# Advisory Plan Commission

## Town of Brownsburg

**Request Type:** Development Plan Review

<b>CASE NUMBER</b>	PSDP-26-2
<b>APPLICANT</b>	Ryan Lindley, Banning Engineering
<b>LOCATION</b>	32-08-30-101-002.000-015. At the SW corner of Ronald Regan Parkway and E County Road 300 N.
<b>PARCEL SIZE</b>	49.87 acres (Lot 1)

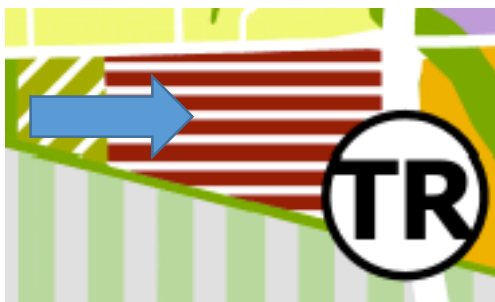
2/2/2026 Capital Projects: "I have concerns with the "pork chop" working without a median or barrier"

2/2/2026 Fire Territory: "Sheet C100 incorrectly lists location in Brown Township. This location is Located in Lincoln Township. No other fire comments"

2/4/2026 Fire Territory: "Servicing fire department should be Brownsburg Fire Territory"

2/4/2026 Street Department: "Will sidewalks be placed alongside the private streets in the future and what is the timeframe if so?"

At TECH review, the applicant came in and we discussed the comments below. The applicant updated the plans to meet our comments.
